# **Project Level Particulate Matter (PM10) Consultation Document**

**SR24  
SR202L (Santan) – Ironwood**

**Project No. 024 MA 000 F0719 01D**

Interagency Consultation Comments

Figure 2. PM Links and Receptors Placement for Air Quality Modeling  
(Elliot Road and SR 202L)

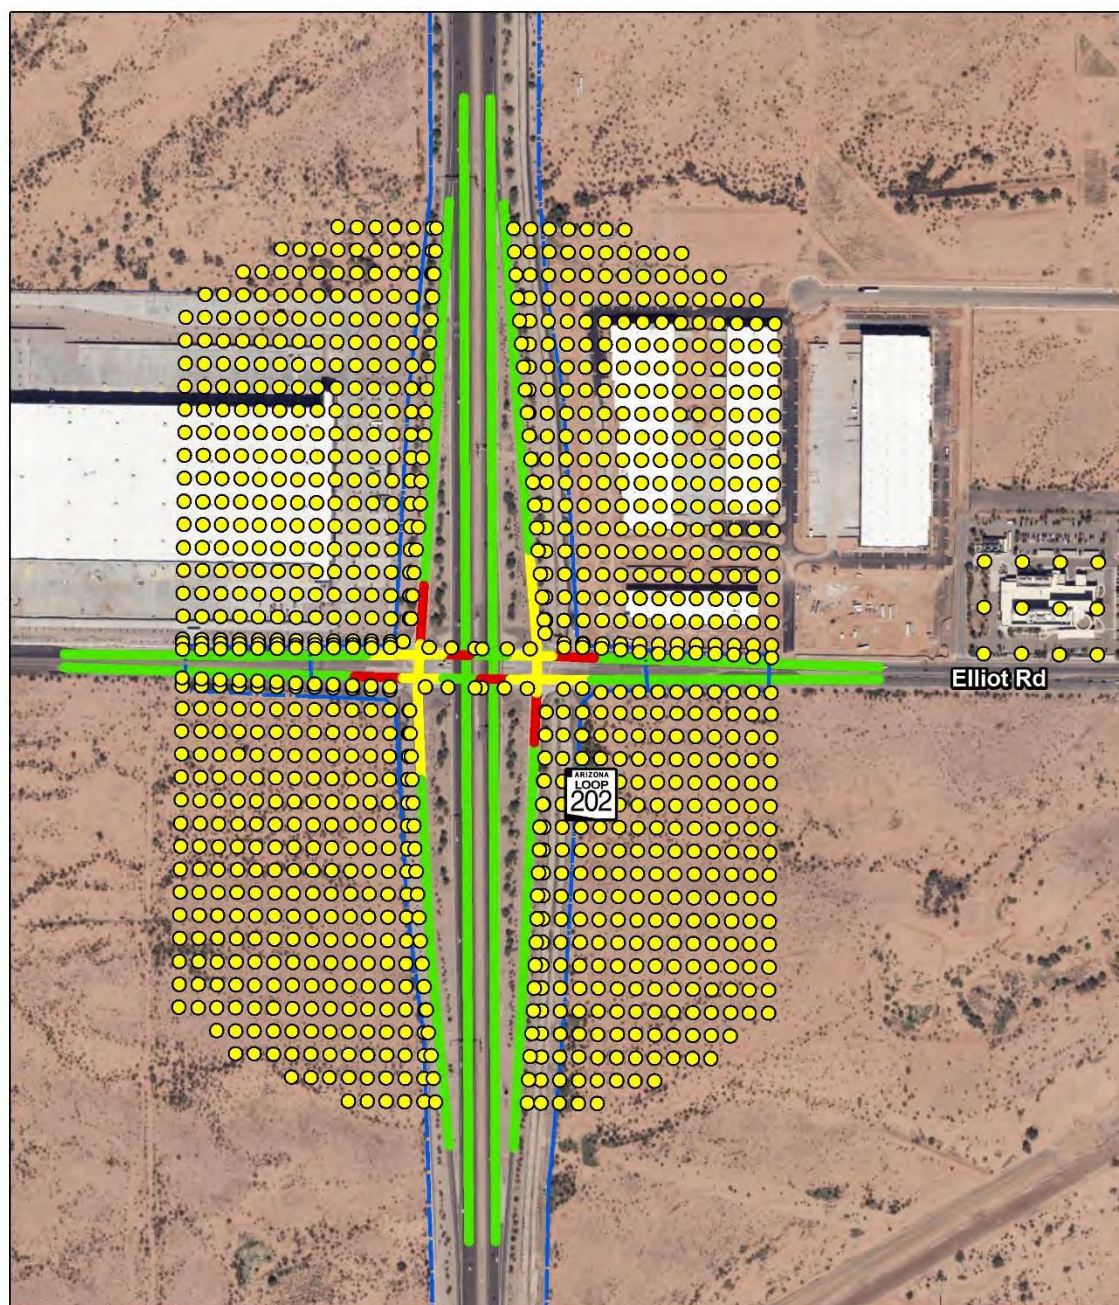
15			Receptors	There are several locations where receptor grids do not include adjacent sensitive populations and locations. For example, the hospital on Elliot Road, the retirement community on Guadalupe Road, and the house located north of SR 24 on Meridian Road. Although the maximum concentrations are within the current receptor grid configuration compliant with PM Hot-spot guidance (p. 80), extending the receptor grid to include these key locations ensures that potential impacts on sensitive areas are adequately assessed and any variations in pollutant concentrations are accurately captured.	Will include receptors in these areas with larger spacing due to further distances to the sources in the next submittal.

Figure 6. PM Links and Receptors Placement for Air Quality Modeling  
 (SR202 and SR 24)

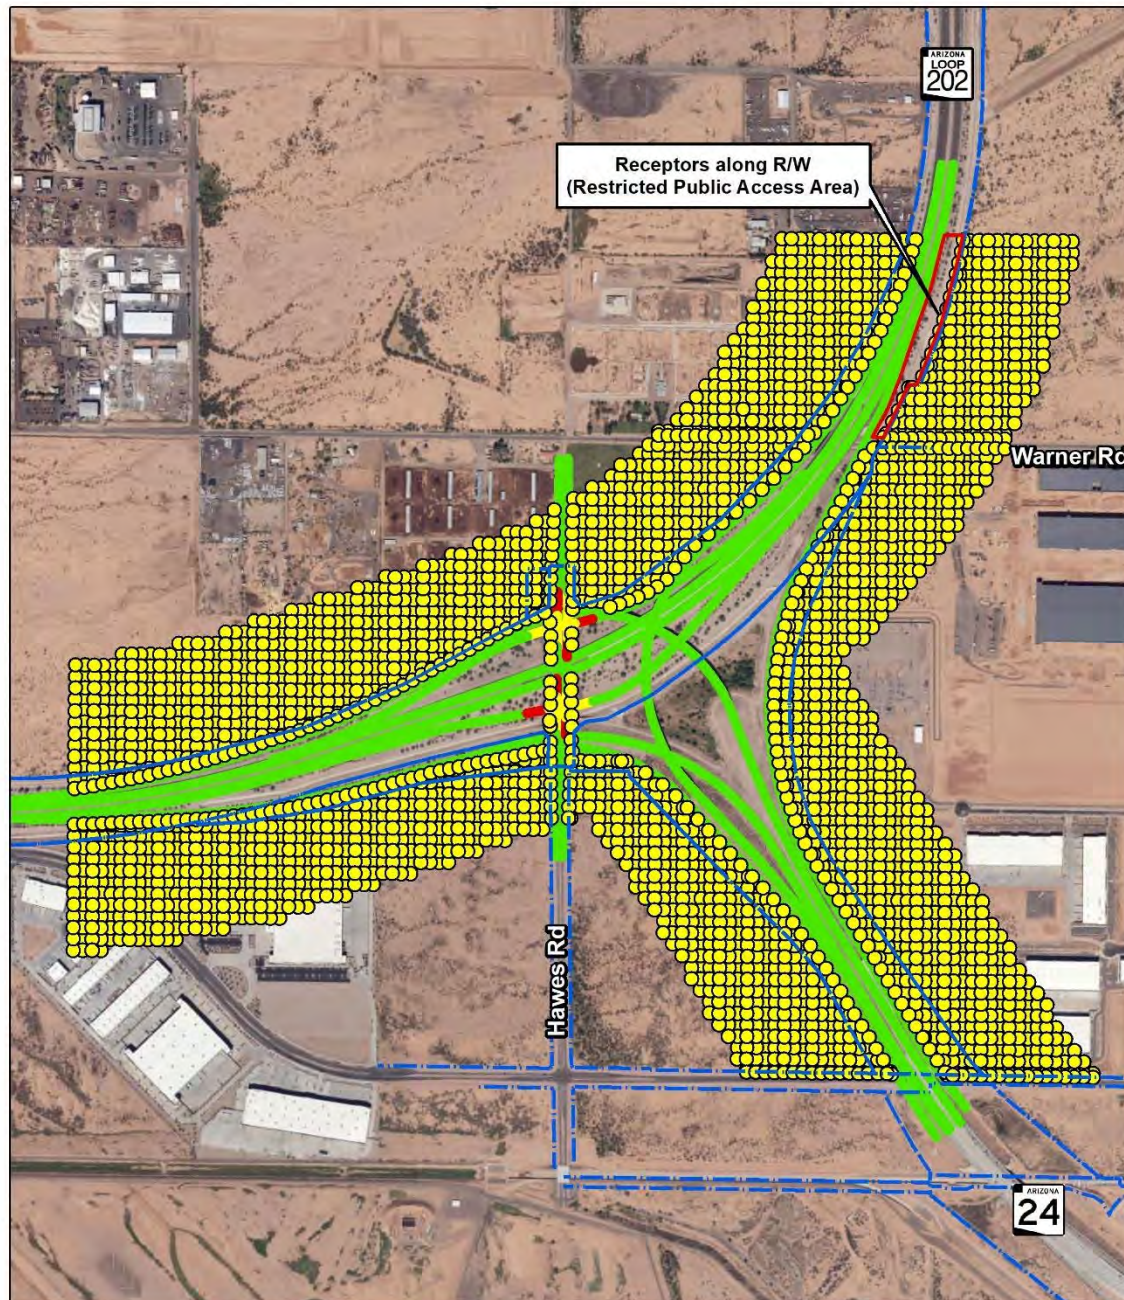
General	As mentioned in EPA's comments, please review AERMOD input files and correct any receptors that fall within the receptor exclusion zone. This can be addressed by either adjusting the size of the volume sources or moving the receptors (if appropriate).	Will double check and move the receptor outside of exclusion zone.
			General	Please add additional discussion and justification for excluding the other intersections/sections of the project from modeling. Specifically, I'm especially concerned about why the interchange of 202 and 24 is not being modeled. This will likely be the area of highest concentration since you have the highest AADT roadways in the project area converging.	Will add additional discussion and justification for excluding the other intersections/sections of the project from modeling. That is mainly because the AADT volumes and truck volumes are less in those intersections than selected intersections for analysis. Will include SR202 and SR24 TI and associated Hawes Rd intersections for analysis.
